Access Compliance Report

Public Rights-of-Way

Intersection ID: 20264	Main Street: DINGESS_RD	Cross Street: MEADHAVEN_DR	Location: E
ADA ID: 24C14F3EDF03	Ramp Type: PerpDiag	Initial Pass/Fail: Fail	Overall Compliance: No
		Severity Score: 22.5

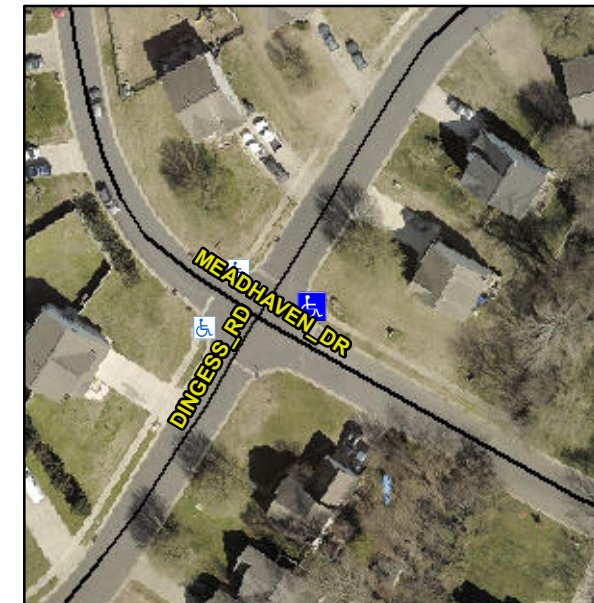
R304.5.1, R304.2.2, R304.5.3

Compliance	Description	Data	Compliance	Description	Data
N/A	Ramp Length (in)	46.0	No	Ramp Slope (%)	8.8
No	Ramp Width (in)	38.0	No	Ramp XSlope (%)	3.1
N/A	Flare Type LT	N/A	N/A	Flare Type RT	N/A
N/A	Flare Slope LT (%)	N/A	N/A	Flare Slope RT (%)	N/A
N/A	Flare Traversable LT?	N/A	N/A	Flare Traversable RT?	N/A
N/A	Landing Length (in)	N/A	N/A	DWS Provided?	N/A
N/A	Landing Width (in)	N/A	N/A	DWS Contrast?	N/A
N/A	Landing Slope (%)	N/A	N/A	DWS Length (in)	N/A
N/A	Landing X Slope (%)	N/A	N/A	DWS Full Width?	N/A
N/A	Landing Curb? (Y/N)	N/A	N/A	DWS Offset (in)	N/A
N/A	Shared Landing?	N/A			
N/A	Gutter Ponding?	N/A	N/A	Gutter Slope (%)	N/A
N/A	Gutter Lip Ht (in)	N/A	N/A	Gutter X Slope (%)	N/A
N/A	Painted X Walk1?	No	N/A	Painted X Walk2?	No
	X Walk 1 Direction	To NW		X Walk 2 Direction	To SW
N/A	X Walk 1 Width (in)	N/A	N/A	X Walk 2 Width (in)	N/A
	X Walk 1 Slope (%)	3.5		X Walk 2 Slope (%)	1.5
	X Walk 1 X Slope (%)	0.8		X Walk 2 X Slope (%)	3.0

Remove & Replace Curb Ramp With Two New Directional Ramps or Equivalent.
